RE: PLUS review 2014-06-01, Reserves at Nassau, Phase 2
Conditional Use Application
Response to PLUS Review 2014-06-01
Tax Map Nos: 3-35-11.00, Parcels 55.00, 56.00, 59.00, 59.01 & 60.00
DBF #0818C013.C01

On behalf of the Applicant, Ocean Atlantic Communities, LLC, we are pleased to submit a response to the PLUS comments received on July 22, 2014 for the proposed Reserves at Nassau Phase 2 Conditional Use.

Army Corps of Engineers Regulated Wetland Lines

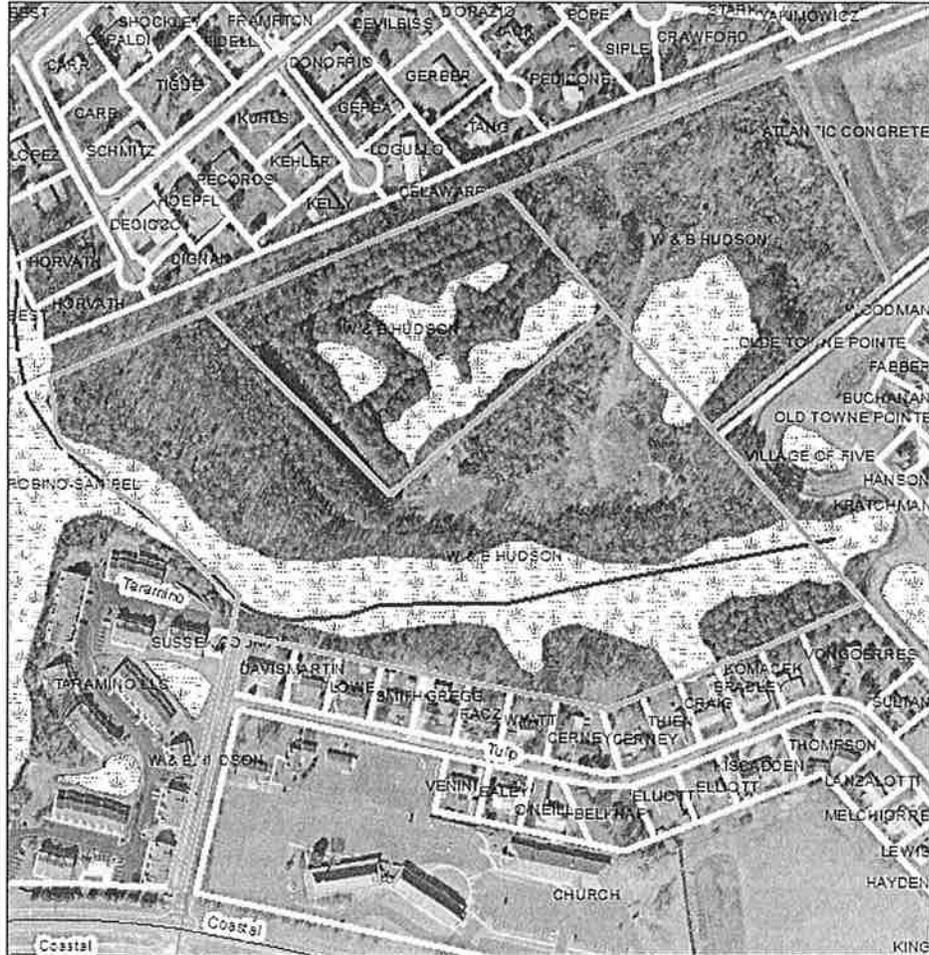
- *State regulated wetlands ARE NOT located on this property based on a review of the State wetland maps. State regulated subaqueous lands ARE likely to be located on this property based on a review of aerial photographs, SWMP maps, Soil Surveys and/or USGS topographic maps. Black Hog Gut Stream runs through the property. State subaqueous lands include all tidal waters (up to the mean high water line), most non-tidal rivers, streams, lakes, ponds, bays and inlets (up to the ordinary high water line), most perennial streams and ditches and many intermittent streams and ditches. Additional information about State regulated subaqueous lands is available by contacting the Wetlands and Subaqueous Lands Section at (302) 739-9943 or on line at <http://www.dnrec.delaware.gov/wr/Services/Pages/WetlandsAndSubaqueousLands.aspx>*

- *Waters of the U.S. regulated by the U.S. Army Corps of Engineers ARE likely to be located on this property based on a review of aerial photographs, SWMP maps, Soil Surveys and/or USGS topographic maps. As stated in the application, wetland permits may be needed. Waters of the United States include the following: navigable waters of the United States; wetlands; tributaries to navigable waters of the United States, including adjacent wetlands and lakes and ponds; interstate waters and their tributaries, including adjacent wetlands; and all other waters of the United States not identified above, such as isolated wetlands, intermittent streams, and other waters that are not part of a tributary system to interstate waters or to navigable waters of the United States, where the use, degradation or destruction of these waters could affect interstate or foreign commerce. The U.S. Army Corps of Engineers can be contacted at (215) 656-6728 or online at <http://www.nap.usace.army.mil/cenap-op/regulatory/regulatory.htm>.*

We thank the Wetlands section for the comments on State Regulated Wetlands and Subaqueous Lands. Should a permit be needed we will contact the Section for additional information.

A wetlands delineation has been completed by the Applicant and submitted to the U.S. Army Corps of Engineers for a jurisdictional determination.

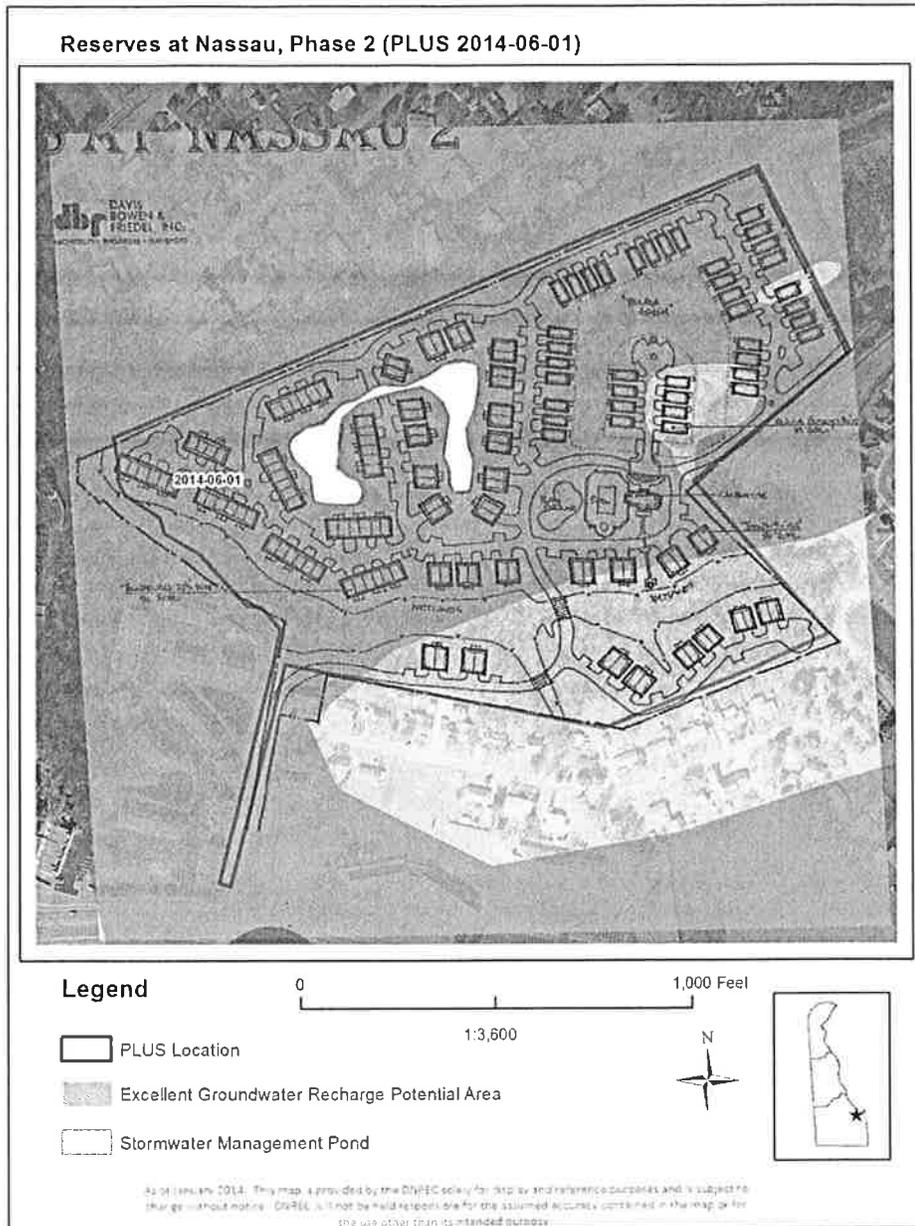
- *The DNREC Water Supply Section, Groundwater Protection Branch (GPB) has determined that a portion of the project site falls within an excellent ground-water recharge potential area for Sussex County (see attached map).*

The site plan shows wet ponds for the management of stormwater (see map below). Wet ponds intersect the water table and have the potential to affect the water quality of the aquifer. Some research suggests that pollutant removal is reduced when ground water contributes substantially to the pool volume (Schueler, 1997). Wet ponds as a Better Management Practice (BMP) utilize a settling pond to remove particulates. This type of BMP reduces nutrients by the biological activity of alga. While these systems address the particulate and nutrient components of stormwater runoff, they do not address pathogens, petroleum hydrocarbons, pesticides, other organic compounds, and other inorganic compounds associated with residential land use (DNREC, 1999). Because this is an area of excellent recharge potential, there

DNREC recommends that wet ponds should be located outside the excellent ground water recharge potential area. In addition, because the excellent ground water recharge area can readily affect the underlying aquifer if contaminants are spilled or discharged across the area, the storage of hazardous substances or wastes should not be allowed within the area unless specific approval is obtained from the relevant state, federal, or local program.

The site plan showed stormwater management in the area of the existing borrow pit. We have read the comment regarding the concern of wet ponds in an excellent recharge area. The overall stormwater management plan has not been designed at this time but will comply with the Sediment and Stormwater Regulations and Sussex County's Source Water Protection Ordinance.

Figure 1: NRCS soil mapping update in the immediate vicinity of the proposed project

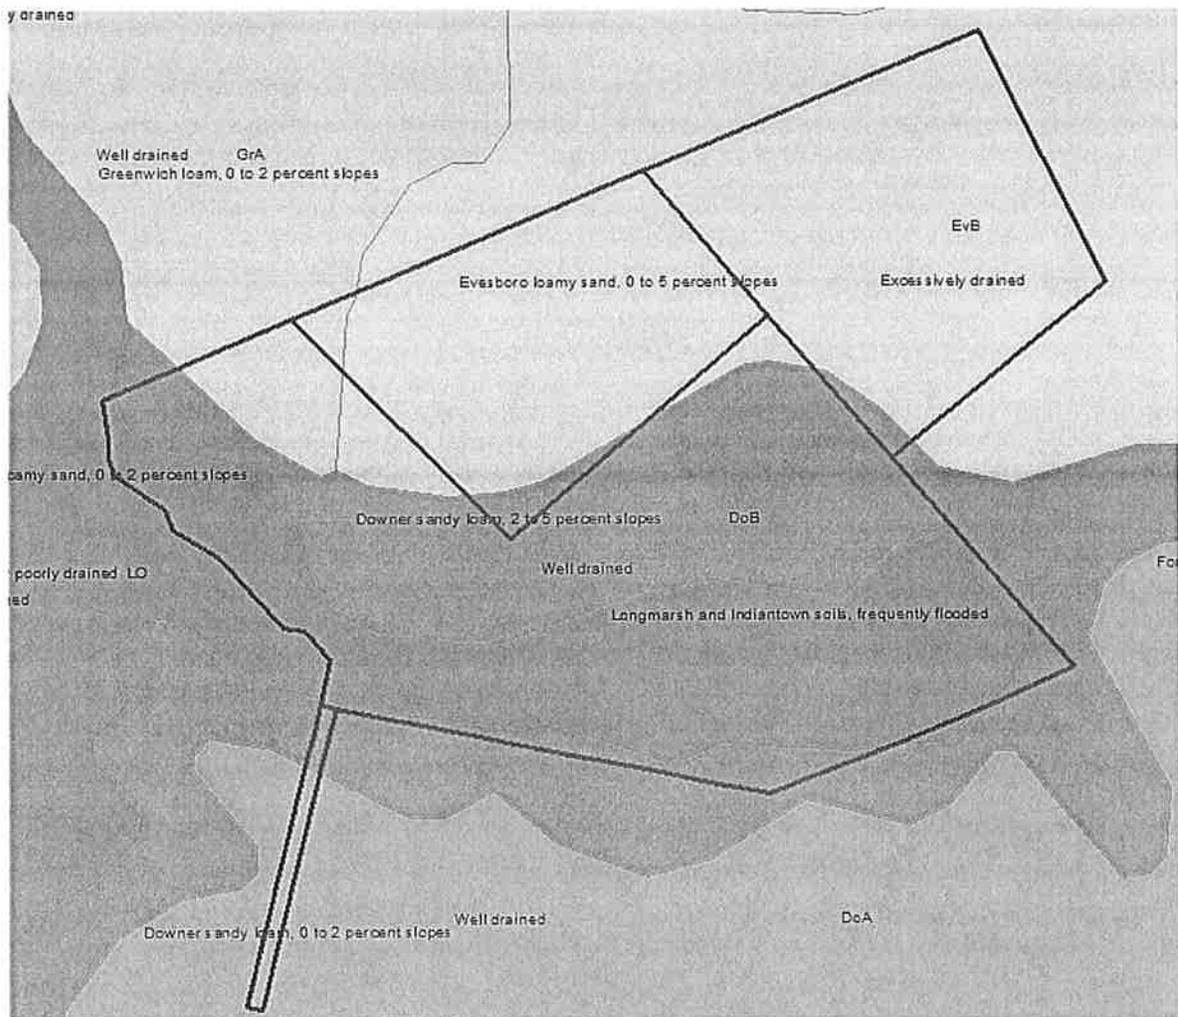
- ***Soils assessment*** *Based on soils survey mapping update, the Longmarsh and Indiantown (LO) soil mapping unit is the main soil mapping unit in the immediate vicinity of the proposed project; we strongly recommend the applicant avoid this mapping unit. LO is a very poorly-drained wetland associated (hydric) soil mapping unit that is considered to have severe limitations for development (i.e., considered unsuitable). Potential unmapped hydric soils may also be present in this parcel.*

The Applicant intends to construct in the well-drained or excessively well drained soils and will avoid the LO mapping unit to the maximum extent practicable.
